Historic Architectural Review Commission
Staff Report for Item 3

Application Number: C2026-0024

Address: 1301 Whitehead Street

New two-story accessory structure, modifications to main contributing structure's existing ~~hip and~~ flat roof~~s~~, and new gable roof over the side entry door.

Proposed First Floor Plan with two-story accessory structure outlined in red.

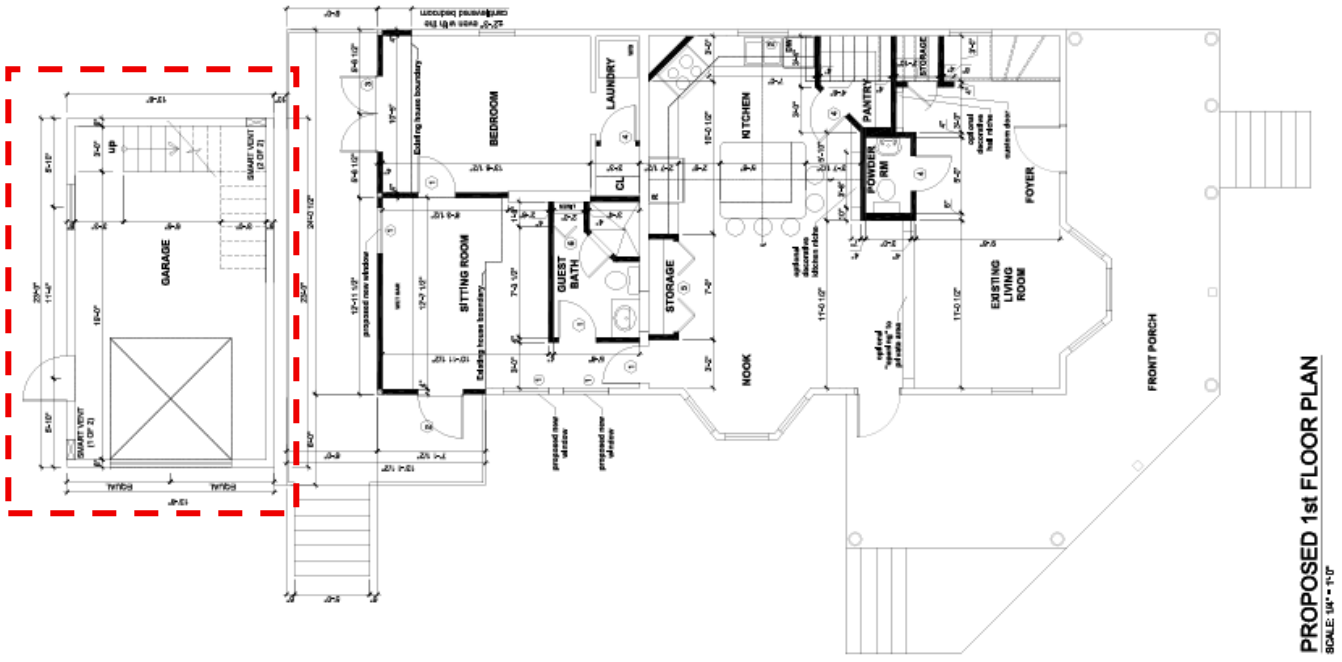
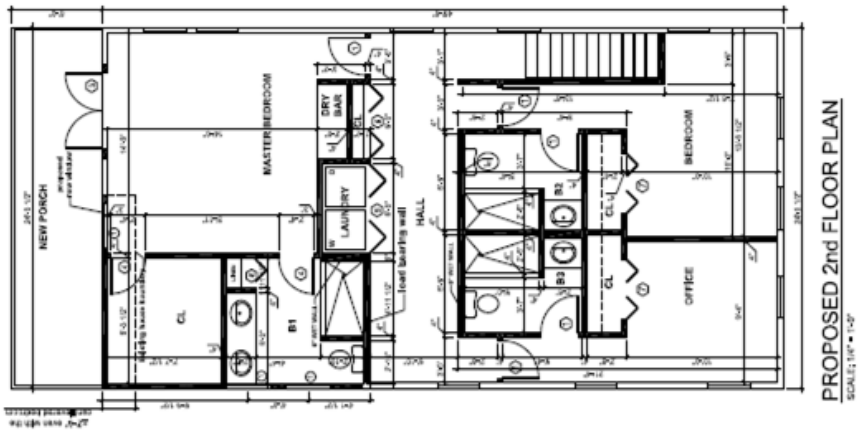
A Certificate of Appropriateness is currently under review for a new two-story accessory structure facing United Street, modifications to the existing flat roof, and a new gable roof cover above an entry door on the United Street elevation.

The new two-story structure will include a garage on the first floor and storage space on the second floor, accessed by a new driveway. The accessory structure will feature Hardie board siding and trim, and metal shingle roofing. On the flat roof, work includes the installation of cable railings, a new textured elastomeric roofing system, copper half-round gutters and downspouts, and enlargement of the existing roof hatch to provide better access. The proposed gable roof cover on the United Street elevation will also feature metal shingle roofing. The only change to the main structure is the addition of metal shingles on the existing bay window and the wraparound porch roof.

Proposed Roof Deck/Attic Plan.

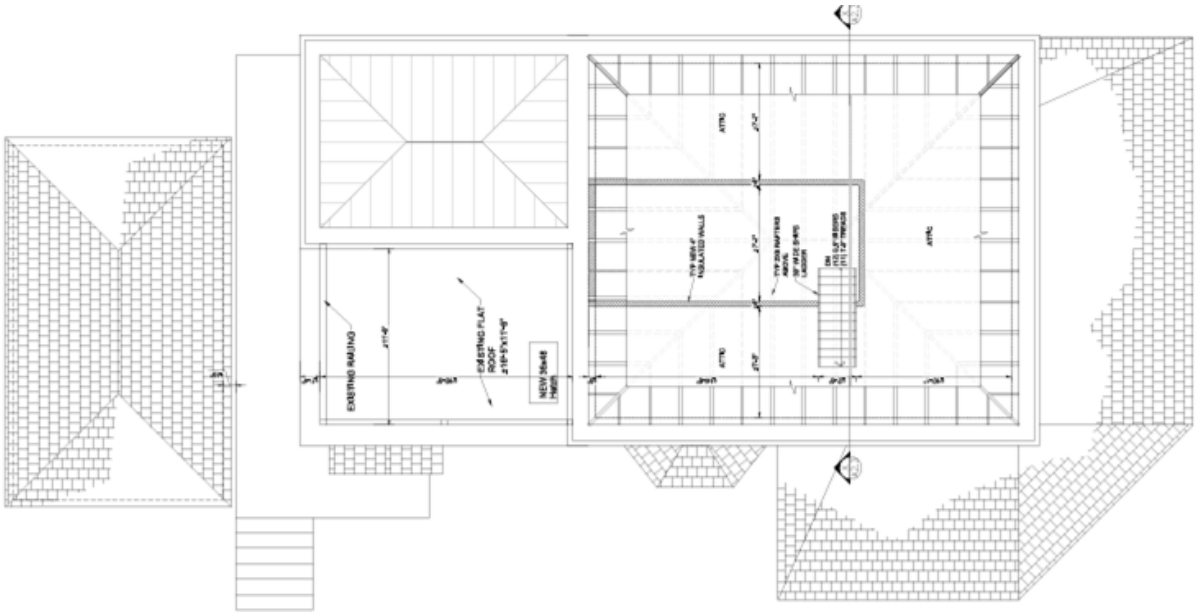
Staff notes that the proposed cable railings on the flat roof will be visible from the public right-of-way and introduce a more contemporary appearance. However, the flat roof area where the railings are proposed is believed to be non-historic. Staff also notes that metal railings can be found on some nearby historic structures, and cable railing systems are seen on newer construction within the surrounding context. The HARC Commission may determine whether the proposed railing system is appropriate within the surrounding context. Staff finds the proposed copper half-round gutters and downspouts to be generally appropriate as well as the enlargement of the flat roof hatch. Although the gutters are proposed on a non-historic addition, the proposed half-round profile is compatible with the historic character of the circa 1912 main structure and surrounding district. The **Gutters Guidelines** state that "the half-round gutter style is most appropriate for buildings constructed prior to 1940."
